PROPOSED TECHNICAL SPECIFICATION

RELOAD 4/CYCLE 5

POWER AUTHORITY OF THE STATE OF NEW YORK  
JAMES A. FITZPATRICK NUCLEAR POWER PLANT  
DOCKET NO. 50-333  
DPR-59

SAFETY EVALUATION

Figure 3.5-9

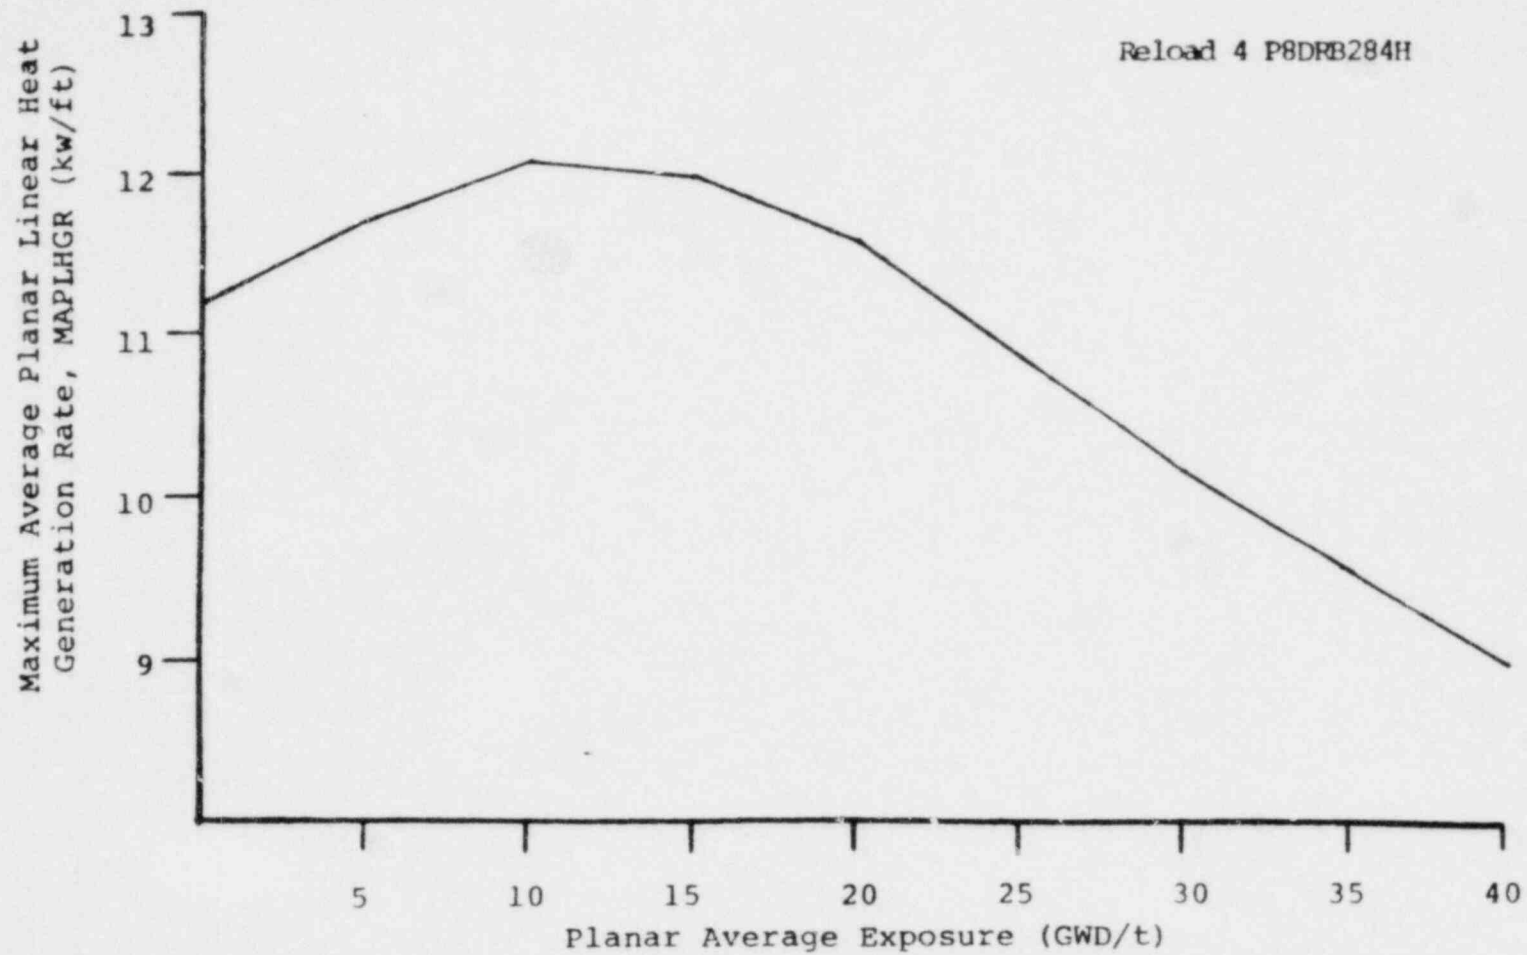
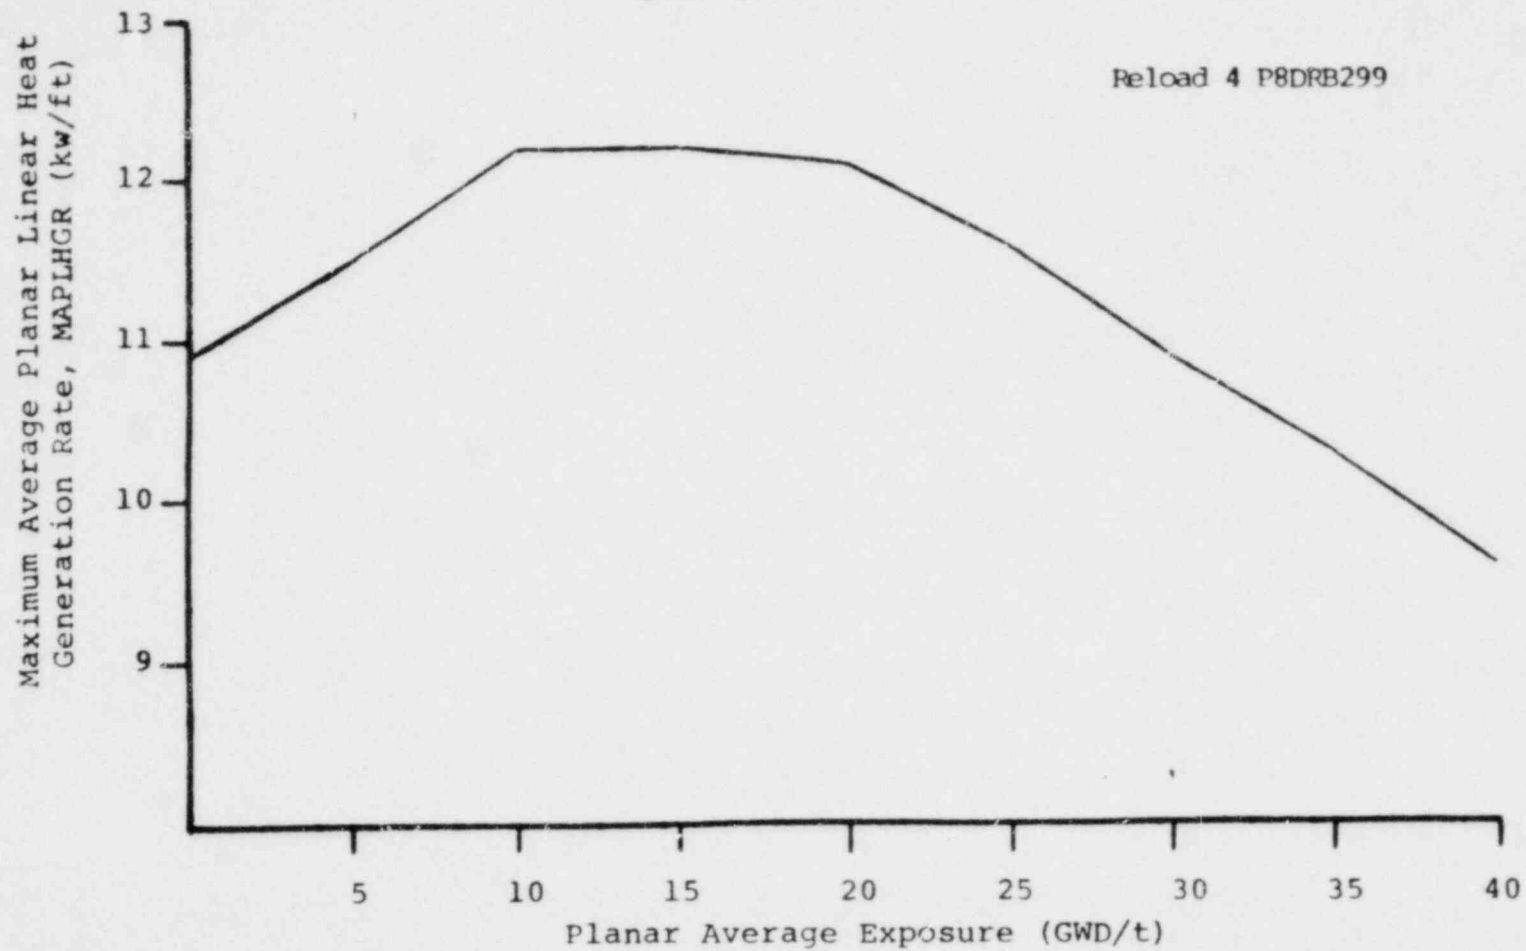
Maximum Average Planar Linear Heat Generation Rate (MAPLHGR) data for two new fuel types is provided in Figures 3.5-9 and 3.5-10. Additionally, the MAPLHGR data for all fuel types remaining in the JAF core (Figures 3.5-3 thru 3.5-8) has been extended from a maximum nodal exposure of 30 GWD/short ton to 40 GWD/short ton. This new MAPLHGR data was developed by General Electric as a revision to the General Electric Report NEDO-21662-2 (Attachment III).

The MAPLHGR curves are being extended in anticipation of exceeding the present 30 GWD/short ton limit in Cycle 5. Based on current predictions of Cycle 5 energy content, the maximum cumulative nodal exposure at end of Cycle 5 will be approximately 36 GWD/short ton.

The extended MAPLHGR limits are an amendment to General Electric report NEDO-21662-2, "Loss-of-Coolant Accident Analysis Report for James A. FitzPatrick Nuclear Power Plant (Lead Plant)" which was submitted to the Commission in a letter from George T. Berry to Robert W. Reid, Chief of Operating Reactor Branch, on July 29, 1977 [Reference (d)]. This report forms the basis of the ECCS analysis for the FitzPatrick plant and SER issued by the Commission on September 16, 1977. Thus the proposed modifications will not alter the conclusions reached in the FSAR accident analysis and SER since they are based on the same plant response calculated in NEDO-21662-2 report and have been calculated using the same approach as the previous MAPLHGR.
